Intersection ID: 50327	Main Street: HENRY_DAVID_CT	Cross Street: SHARPES_CR	Location:	SW
ADA ID: B86074CE0544	Ramp Type: PerpDiag	Initial Pass/Fail: Fail	Overall Compliance: No	Severity Score: 46.25

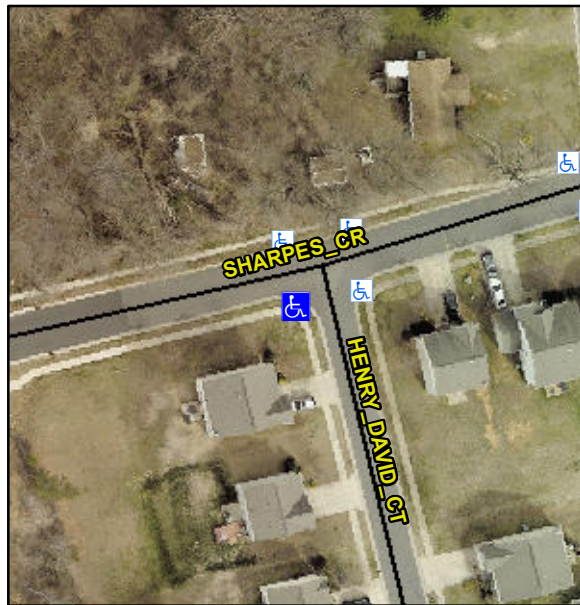
**Not Found, R304.5.1, R304.2.2,
R304.5.3**

Compliance	Description	Data	Compliance	Description	Data
N/A	Ramp Length (in)	48.0	No	Ramp Slope (%)	9.4
No	Ramp Width (in)	41.0	No	Ramp XSlope (%)	12.3
N/A	Flare Type LT	N/A	N/A	Flare Type RT	N/A
N/A	Flare Slope LT (%)	N/A	N/A	Flare Slope RT (%)	N/A
N/A	Flare Traversable LT?	N/A	N/A	Flare Traversable RT?	N/A
N/A	Landing Length (in)	N/A	N/A	DWS Provided?	N/A
N/A	Landing Width (in)	N/A	N/A	DWS Contrast?	N/A
N/A	Landing Slope (%)	N/A	N/A	DWS Length (in)	N/A
N/A	Landing X Slope (%)	N/A	N/A	DWS Full Width?	N/A
N/A	Landing Curb? (Y/N)	N/A	N/A	DWS Offset (in)	N/A
N/A	Shared Landing?	N/A			
N/A	Gutter Ponding?	N/A	N/A	Gutter Slope (%)	N/A
N/A	Gutter Lip Ht (in)	0.5	N/A	Gutter X Slope (%)	N/A
N/A	Painted X Walk1?	No	N/A	Painted X Walk2?	No
	X Walk 1 Direction	To E		X Walk 2 Direction	To N
N/A	X Walk 1 Width (in)	N/A	N/A	X Walk 2 Width (in)	N/A
	X Walk 1 Slope (%)	12.4		X Walk 2 Slope (%)	2.3
	X Walk 1 X Slope (%)	2.0		X Walk 2 X Slope (%)	11.0

Remove & Replace Curb Ramp With Two New Directional Ramps or Equivalent.
